**LETTER TO INDUSTRY**  
**LTI #. 00000004**

**DCSM REFERENCE:** Article 5  
Detail W-4.0

**SUMMARY OF ISSUE/TOPIC:** Air release valve piping shall extend to a point above finished grade

CITY OF MANASSAS, VIRGINIA  
 DEPARTMENT OF PUBLIC WORKS

**AIR RELEASE VALVE SETTING**

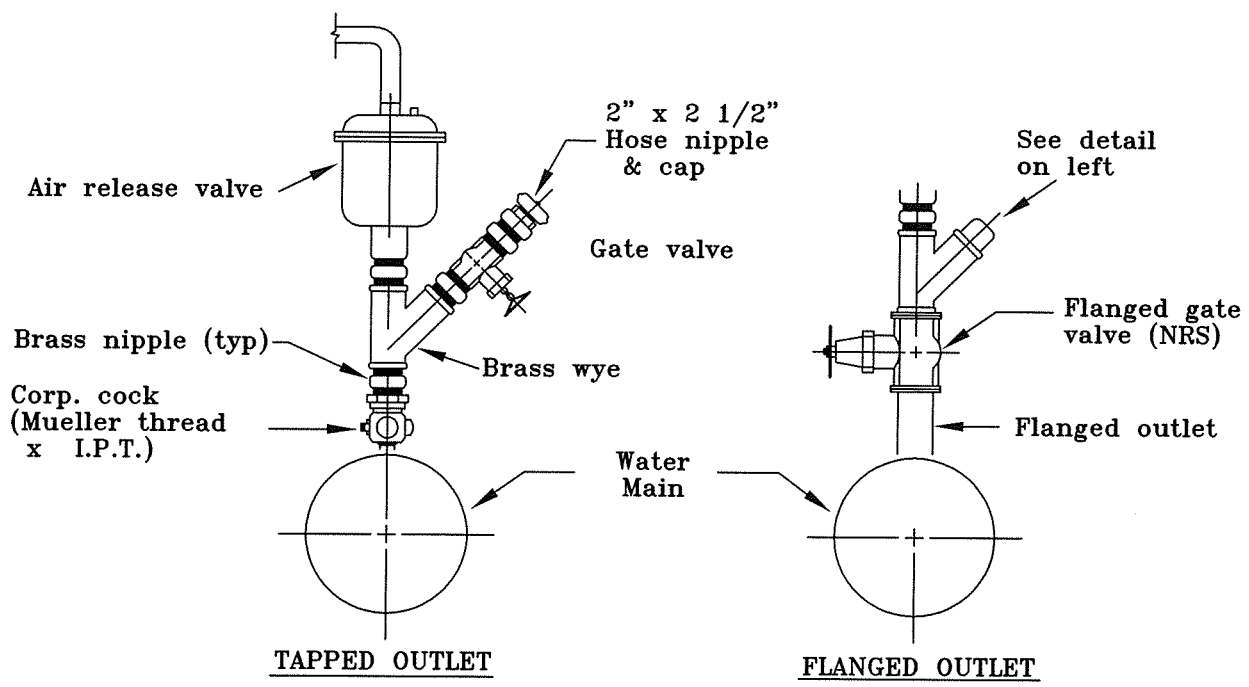
**POLICY / REQUIREMENTS / GUIDELINE:** Replace existing Detail W-4.0 with the attached Detail W-4.0

**BACKGROUND:** The Virginia Department of Health (VDH) requires that all air release vent piping extend to a point above the vault's surface. Detail changes address this requirement.

- NOTES:**
1. Air release valve and piping shall be 2-inch unless indicated otherwise.
  2. Air valves shall not be located in areas subject to flooding or high water table. Special vent piping will be required for these cases.
  3. Tapping saddles shall be used where directed.
  4. Concrete vault penetration shall be core bit drilled.
  5. The air vent pipe shall be 1' MIN. in height and shall be supported by a 4" steel pipe, which is filled with concrete and supported with two (2) stainless steel clamps.
  6. When an above ground extension is not practical or desired the end of the relief pipe or blowoff shall be extended to the top of the pit or chamber
